Cabazon Civic Center – Bid Addendum #3

Date: March 18, 2011

CONTENTS OF ADDENDUM #3 TO THE CONTRACT DOCUMENTS PREPARED BY HARLEY ELLIS DEVEREAUX, DATED 1/1/2011

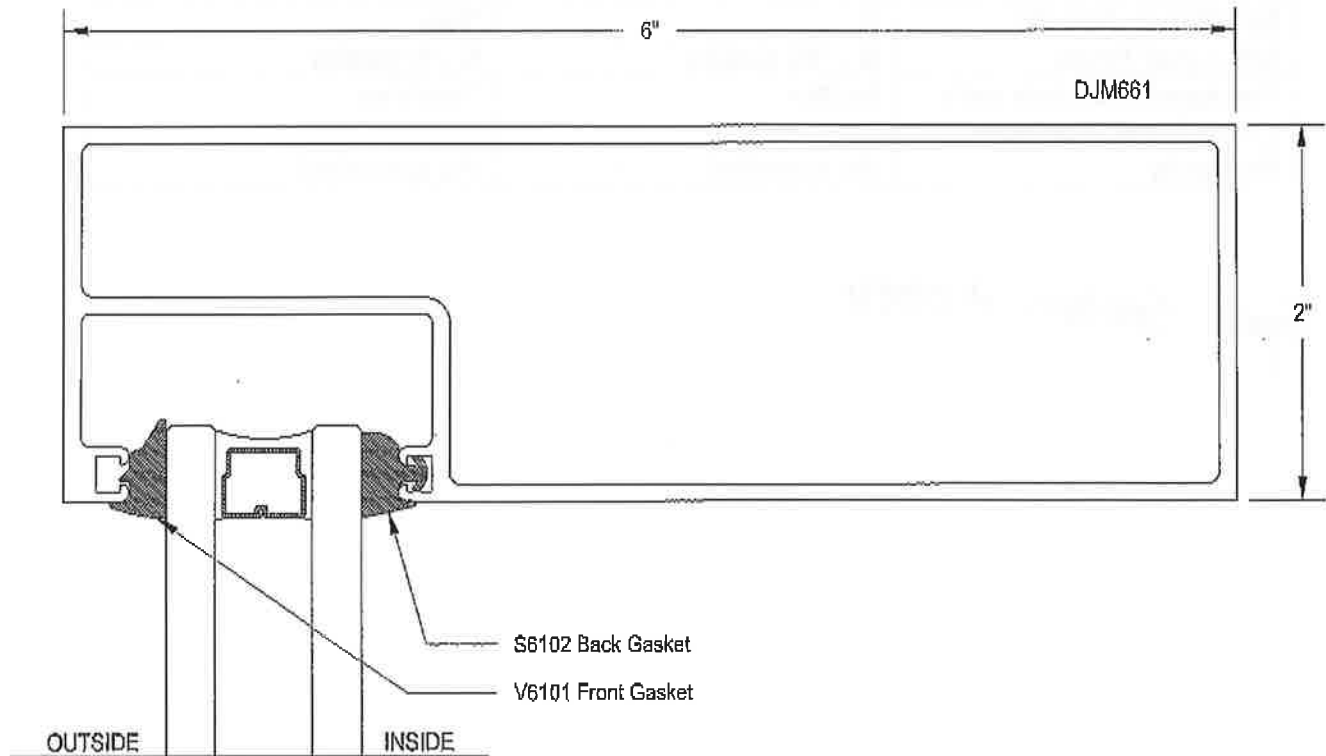
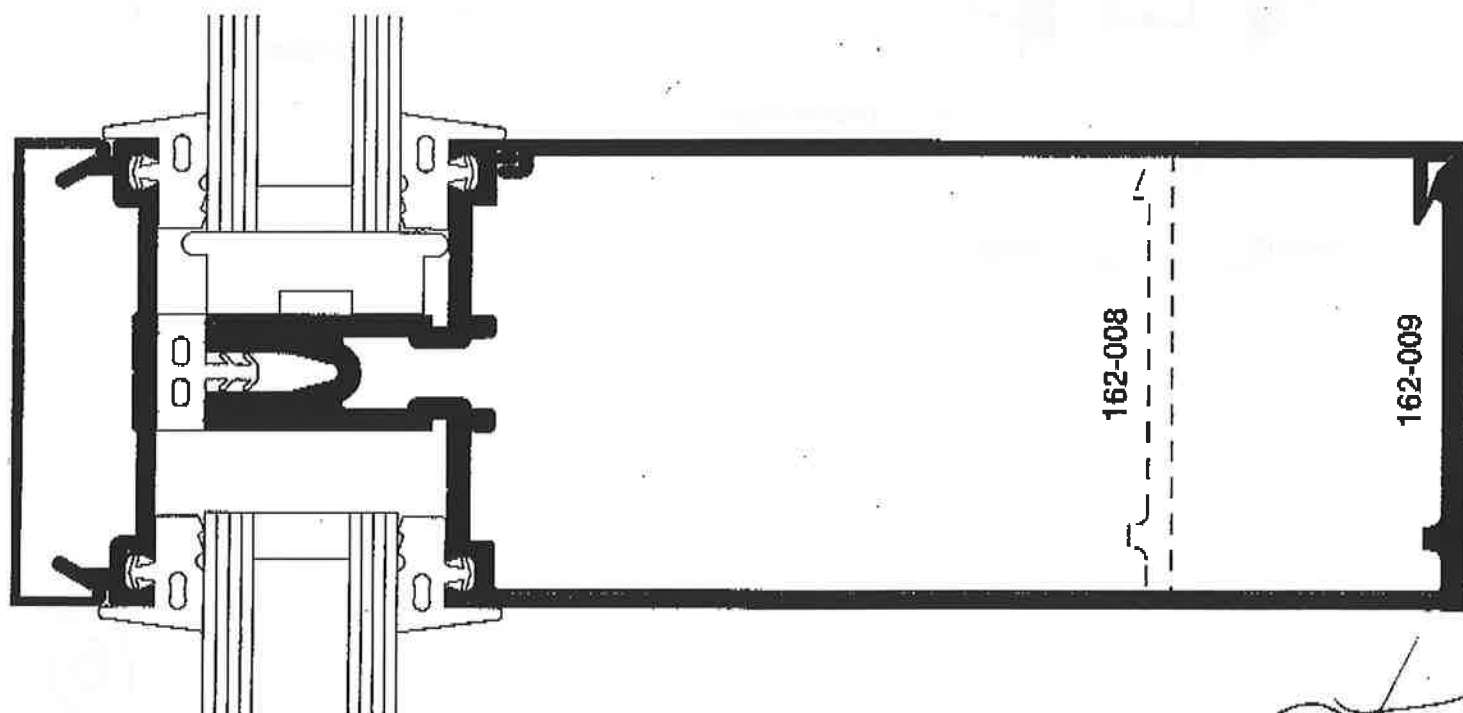
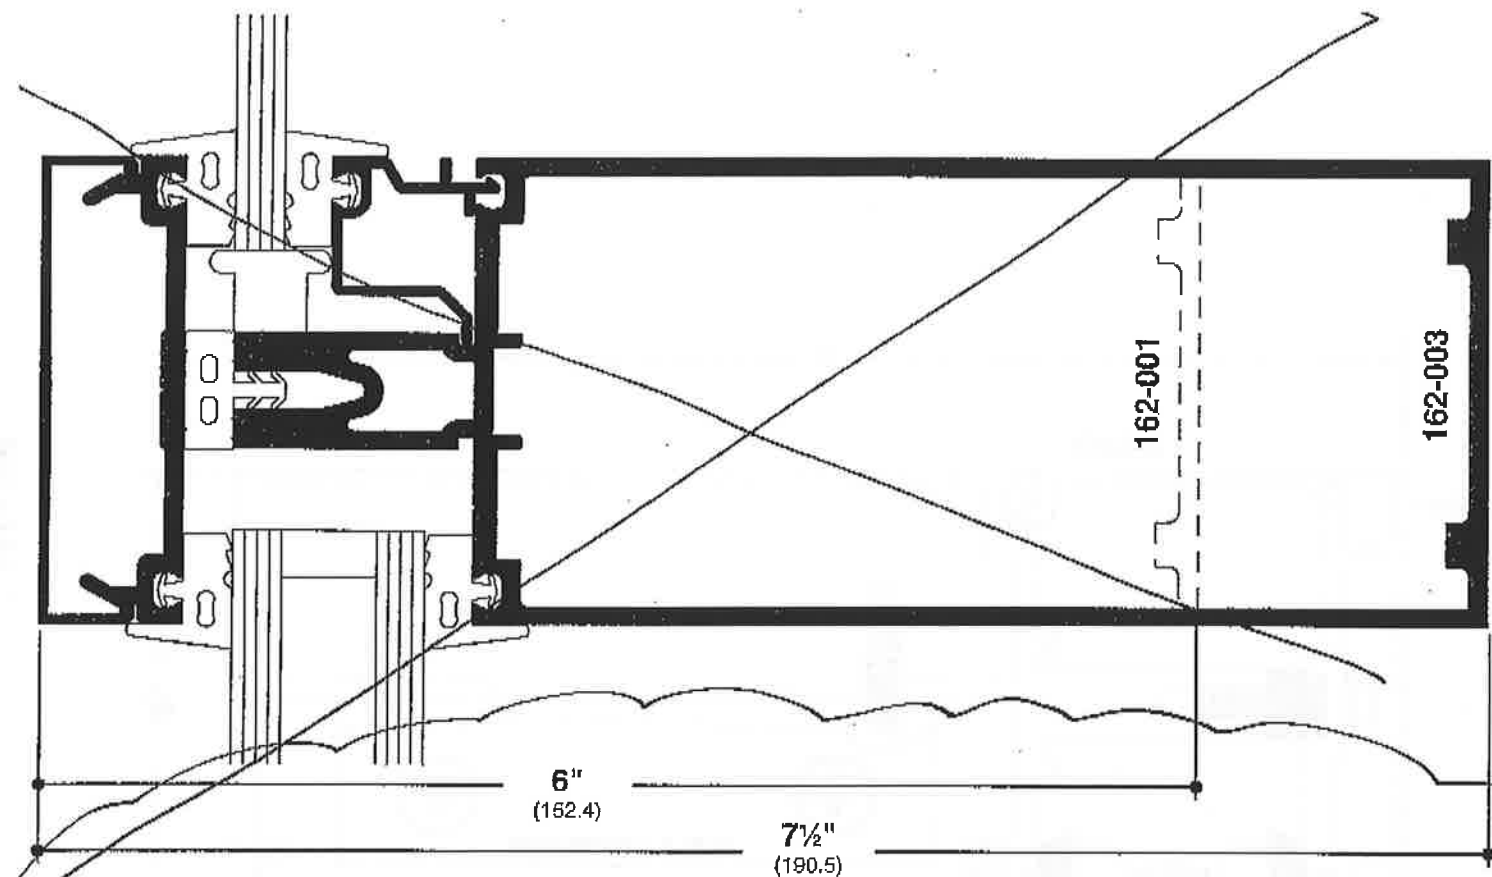
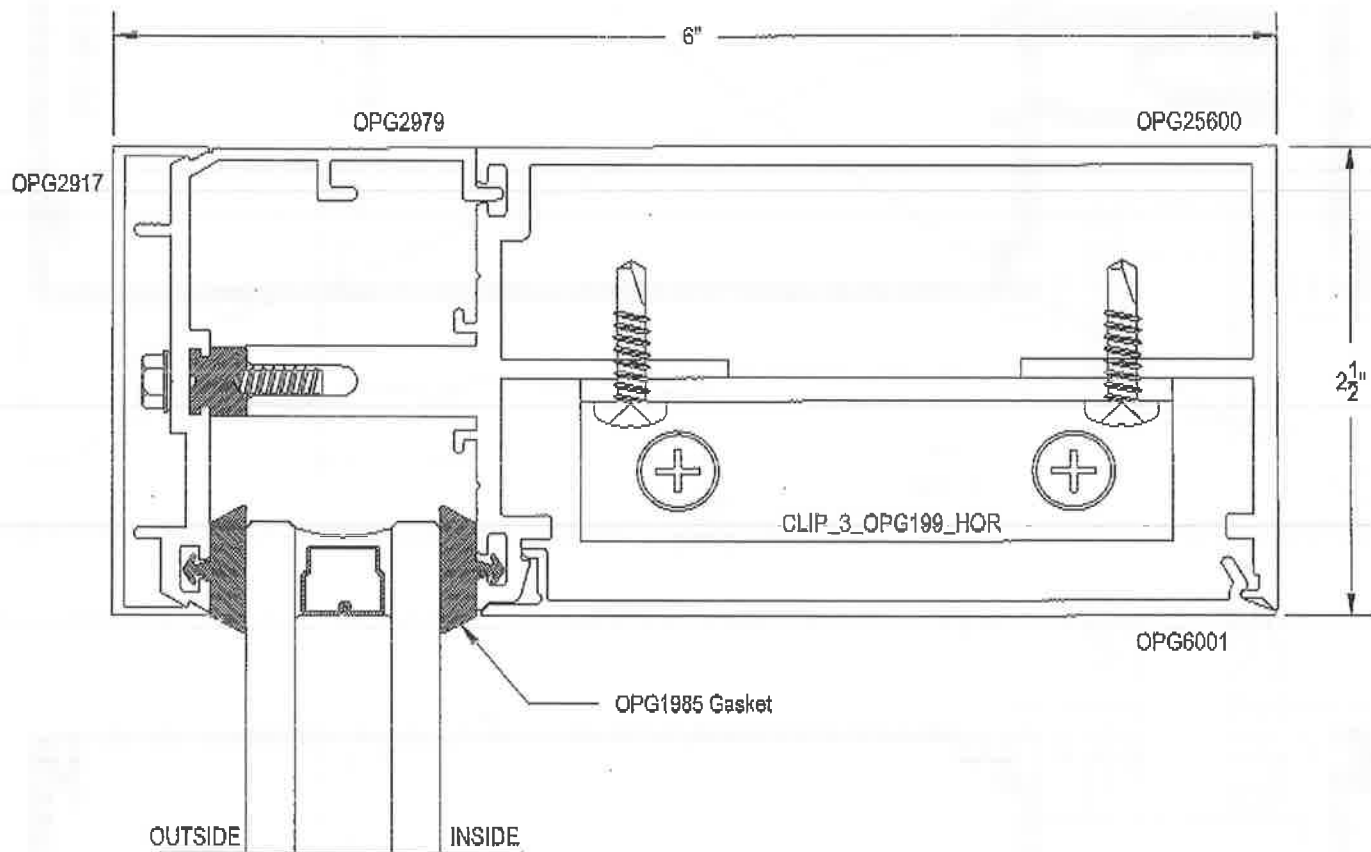
Drawing No. / Detail: Exterior Elevations A5-21 / Window Details A5-61 Spec. Section / Paragraph: 08305, 08410, 08911 / 2.1A

Kawneer Trifab 601 details not found on
the kawneer.com website.
